Access Compliance Report Public Rights-of-Way (Curb Ramps)

Main Street: FOLLATE_WAY		Cross Street: FALLOW_LN		Location:	SW
ADA ID: RPRK211115132154	Ramp Type: Type 4 - Parallel	Initial Pass/Fail: Fail	Overall Compliance: No	Severity Score:	16
Codes/Mitigation Info/Possible Solution			Field Measurements/Component Compliance

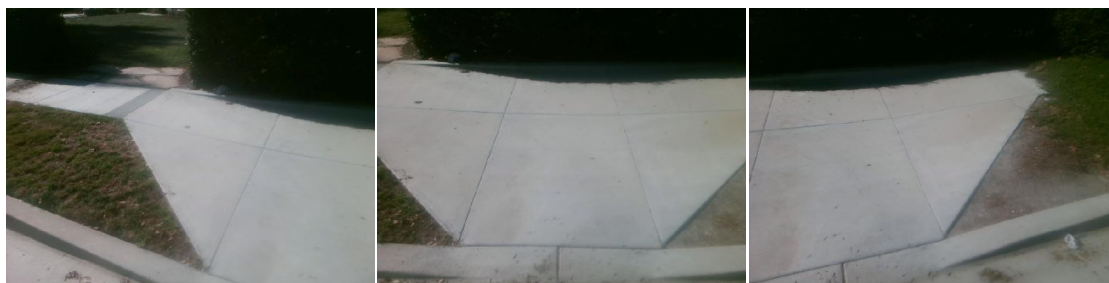
R304.5.3, R304.3.2, STD 1115

Remove & Replace Entire Ramp.
